**Planned Unit Development -
Lots 1 & 16 Harrison Hills—Streck, Inc.**

RECOMMENDATION REPORT

CASE NUMBER: PPUD-19-0002

RE: Planned Unit Development – Initial Review
Streck, Inc. – Harrison Hills

PLANNED UNIT DEVELOPMENT
LANDSCAPE PLAN EXHIBIT
OVERALL SITE

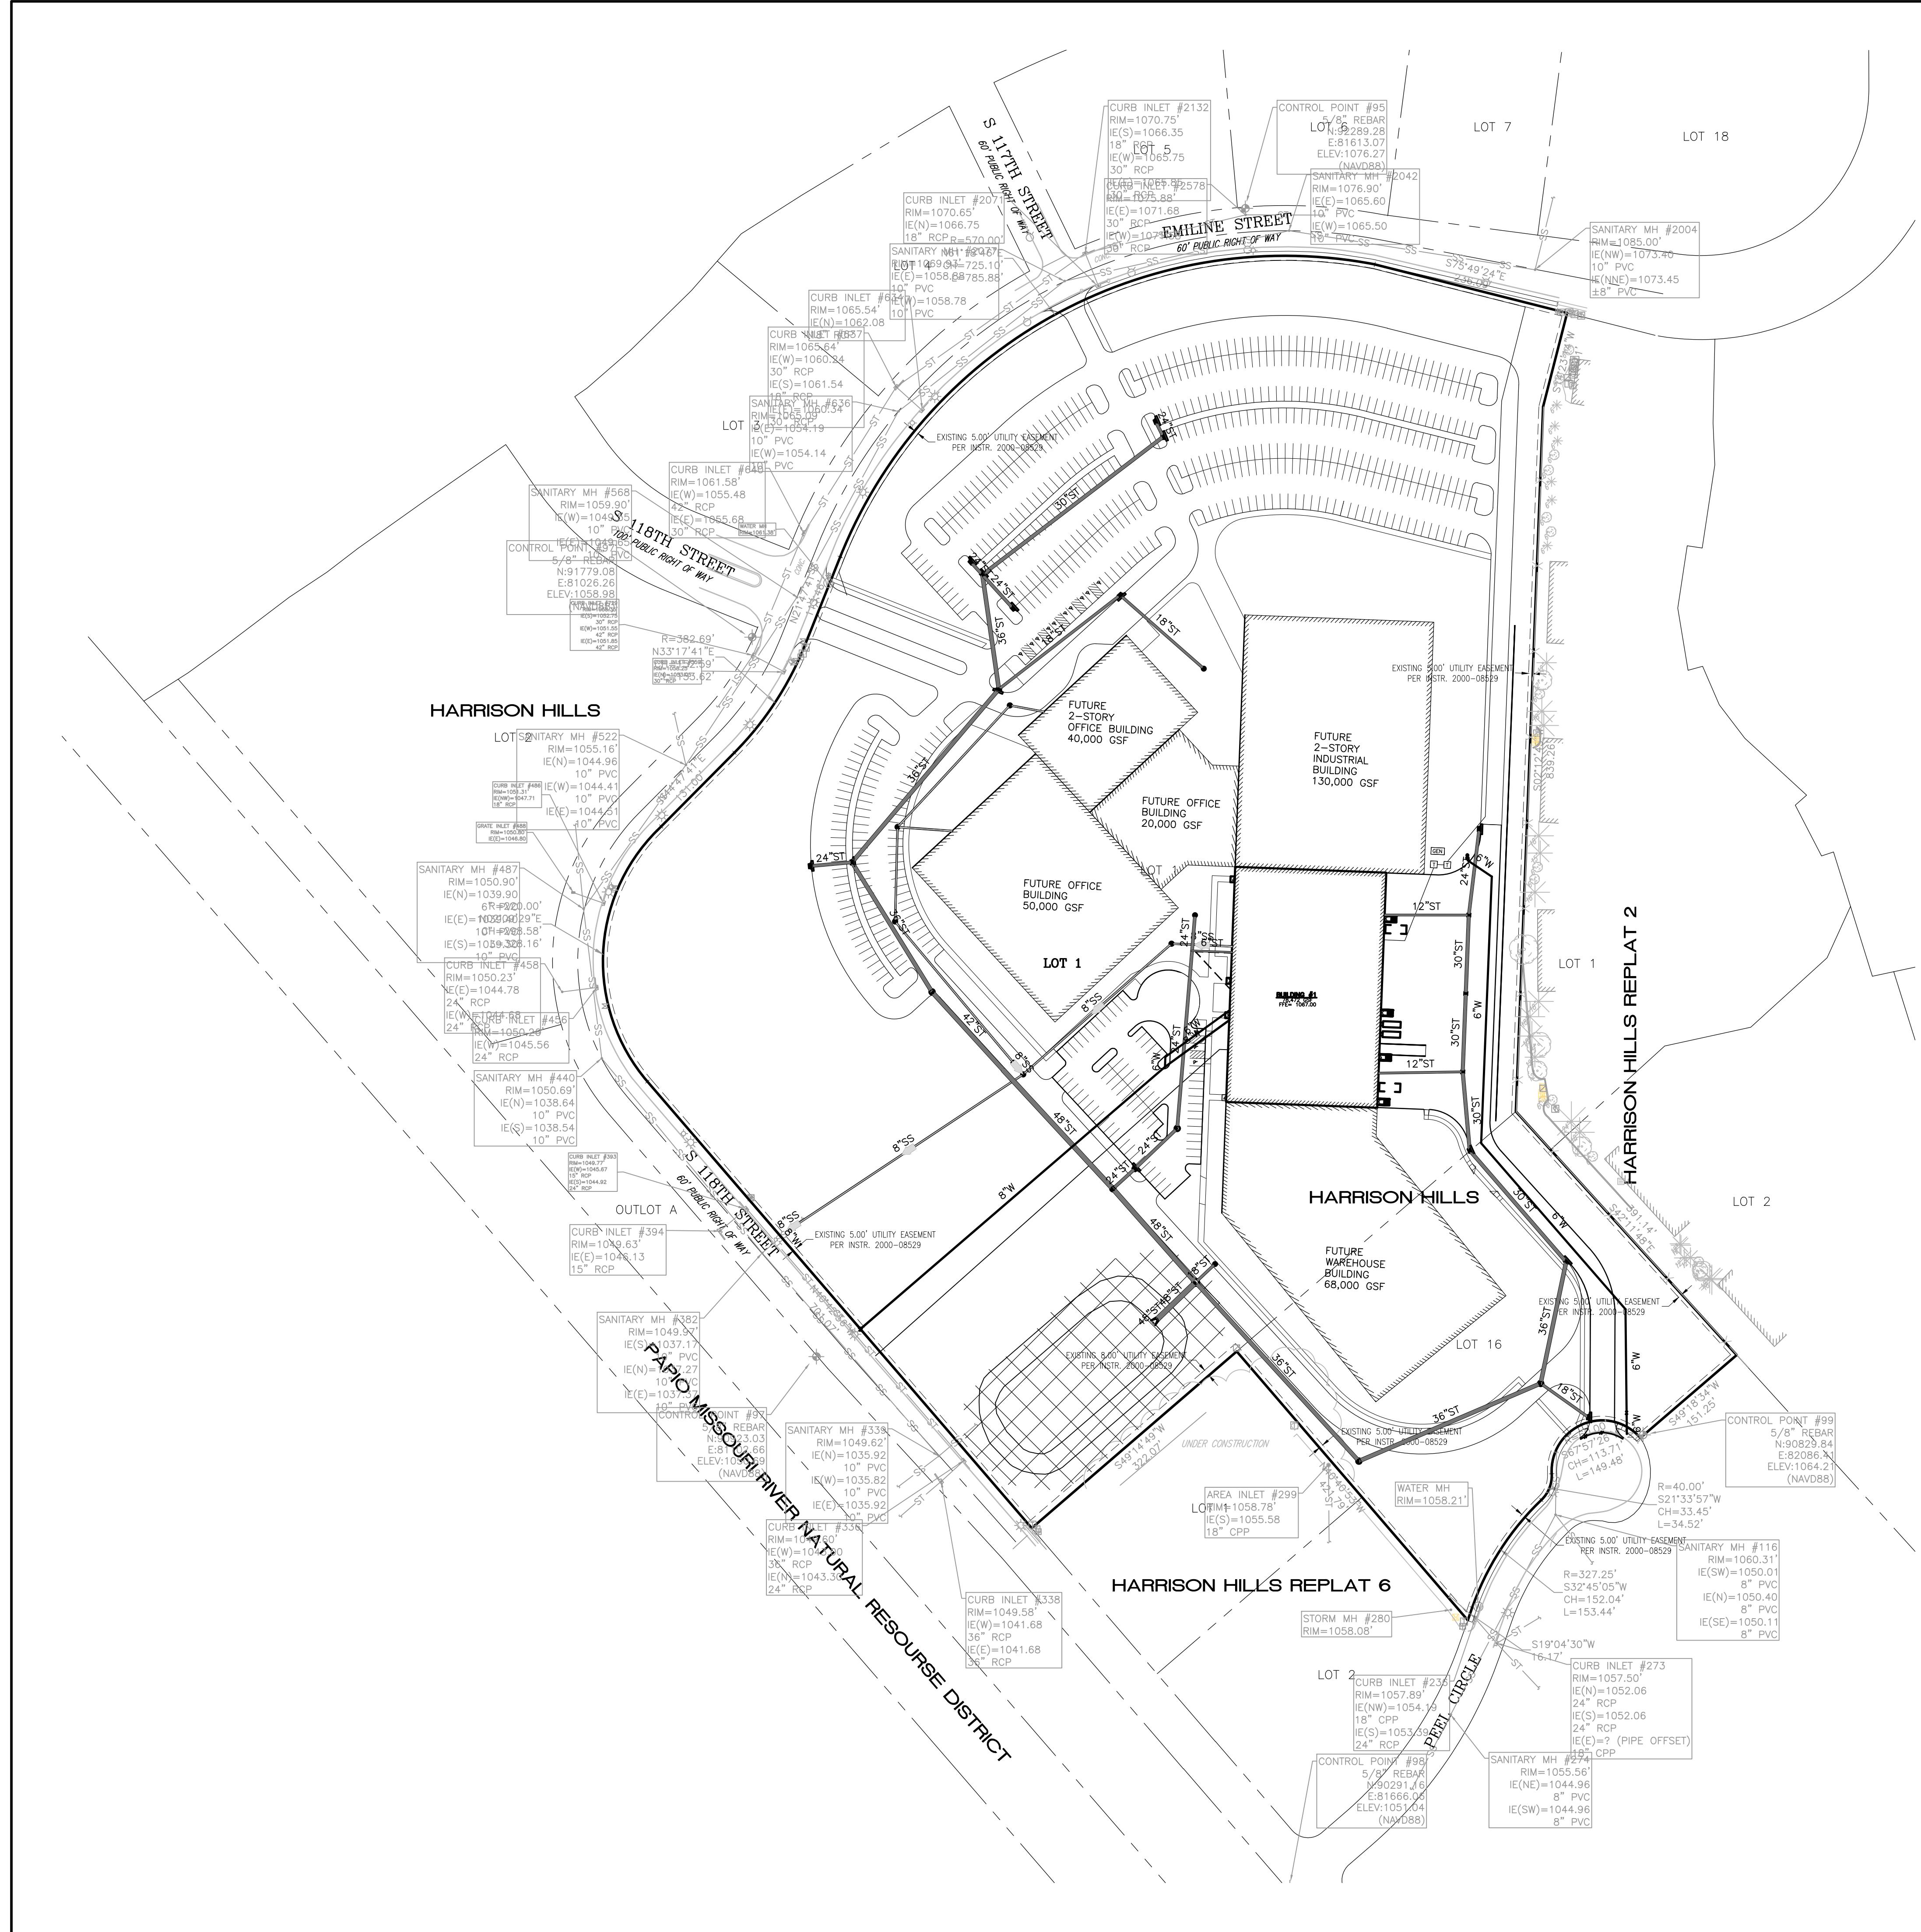
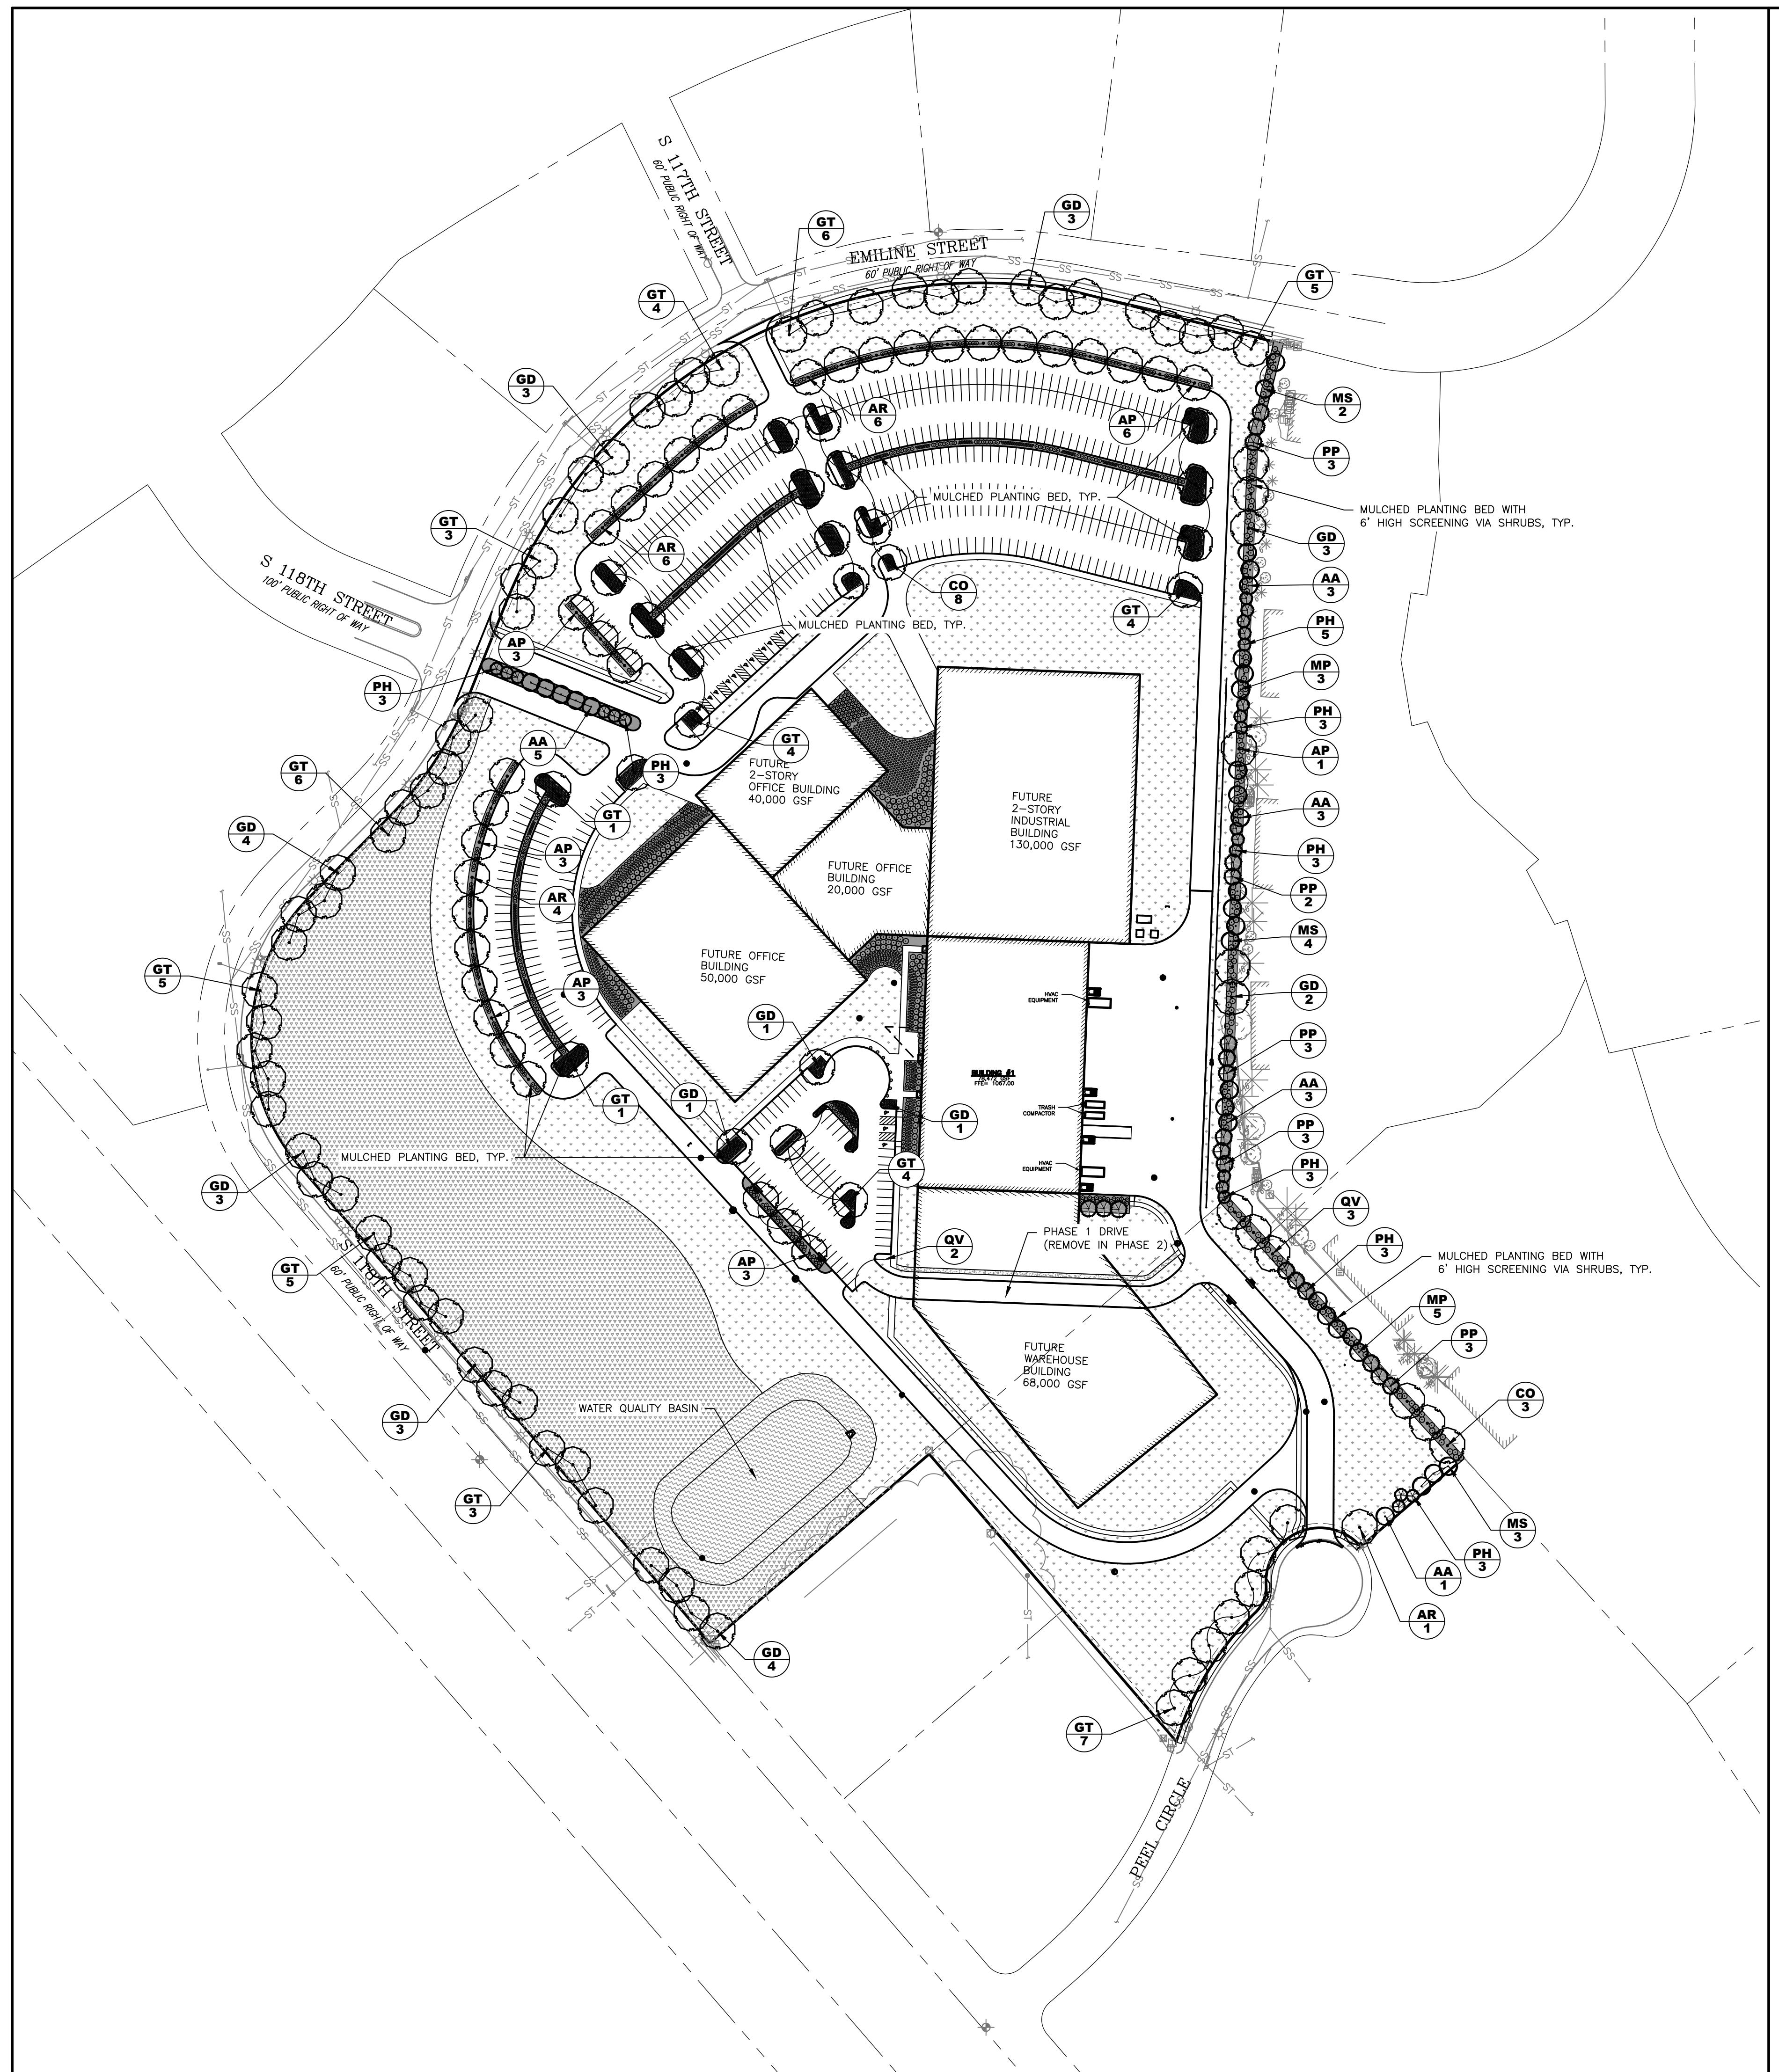
1. (a.) Landscape shall be designed to provide natural undulating landscape forms. Avoid consistent straight line plantings. See Section 4, III, A and 4, III, F.
 - i. Straight line plantings should be avoided. Serpentine plantings or plantings in clumps are preferred.

2. (b.) All landscaping shall be in compliance with the Landscaping Requirements from the City of La Vista Zoning Ordinance. See Section 4, IV, L.
 - i. 7.17.0303, 2 requires side yard landscaping abutting a Residential District to form a 6'-0" high hedge screen or a random or informal screen of plant materials substantially blocking the views. While the addition of burning bushes is an improvement, there are still large runs of tall deciduous trees that will not substantially block views.

Response: Plantings along Emilie Street and South 118th Street have been revised to be located with a serpentine geometry or be planted in clumps.

Response: The side yard plantings along the east property line abutting the residential district have been revised to add continuous line of shrubs anywhere deciduous trees are located. This includes both large shade trees and smaller ornamental trees. Areas currently showing coniferous/evergreen trees have been left as is, to provide year round screening as well as variety in between the deciduous plantings.
